Economic Commission for Europe**Inland Transport Committee****World Forum for Harmonization of Vehicle Regulations****Working Party on Noise****Sixty-third session**

Regulation No. 28 (Audible warning devices)**Proposal for Supplement 5 to Regulation No. 28****Submitted by the expert from the Russian Federation***

I. The audible warning device(s)

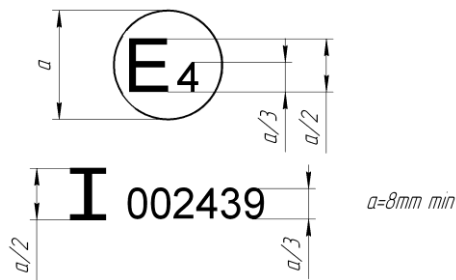
The above approval mark affixed to an audible warning device shows that this audible warning device of Class I has been approved in the Netherlands (E 4) under approval number 002439. The first two digits of the approval number indicate that the approval was granted in accordance with the requirements of Regulation No. 28 in its original form.

Microphone positions for measurements of acoustics parameters of audible warning devices

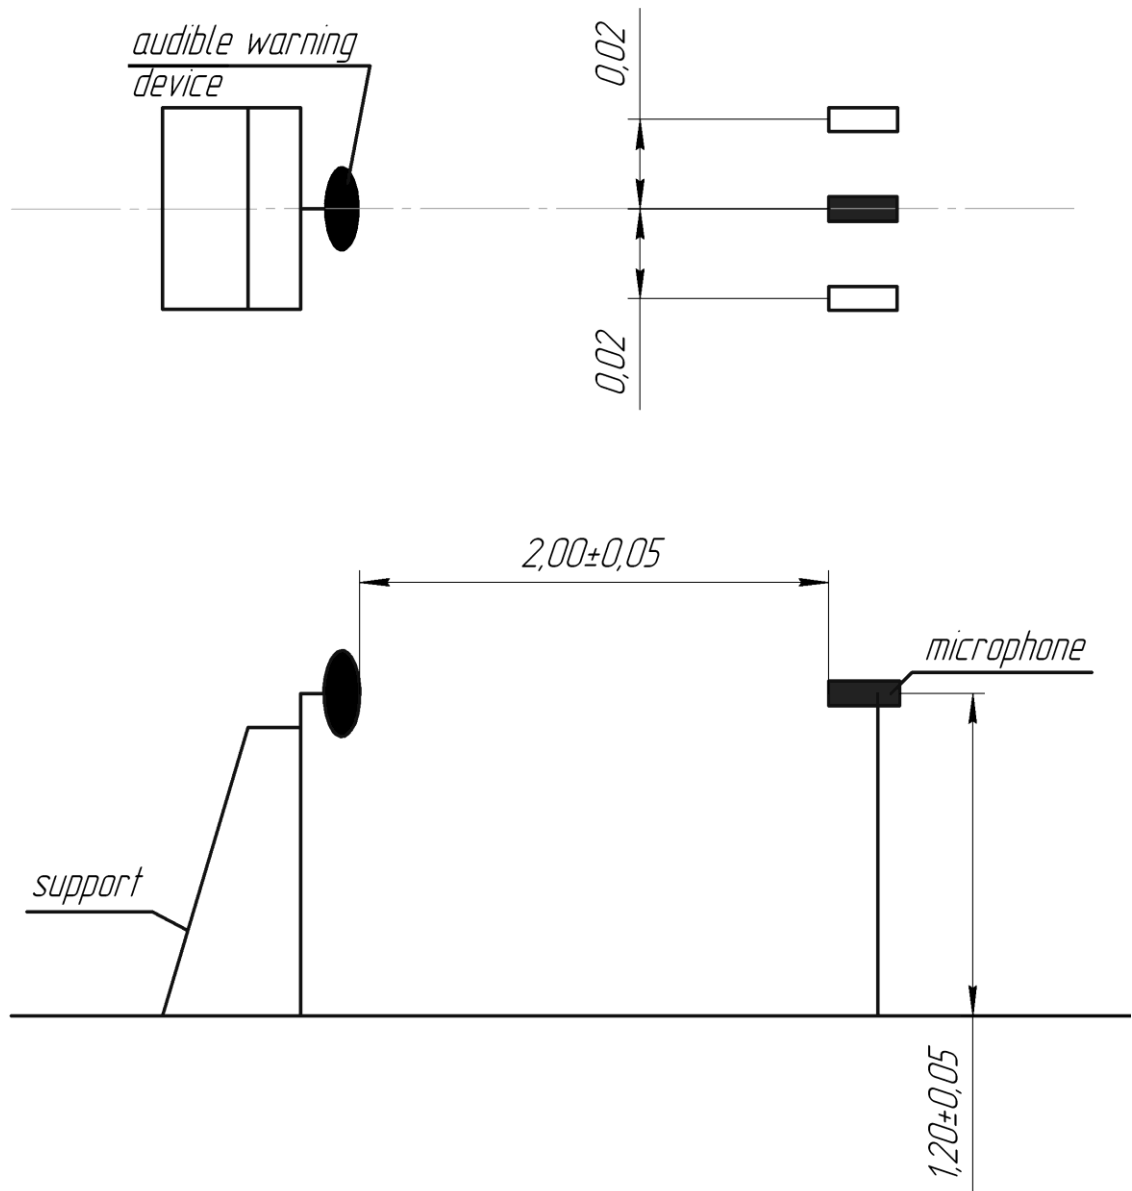
The microphone shall be so placed that its diaphragm is at a distance of 2.00 ± 0.01 0.05 m from the plane of the sound outlet of the device. **The microphone must be positioned facing the front surface emitting sound of the warning device in the direction in which the maximum sound level can be measured. See figure in Annex 3.**
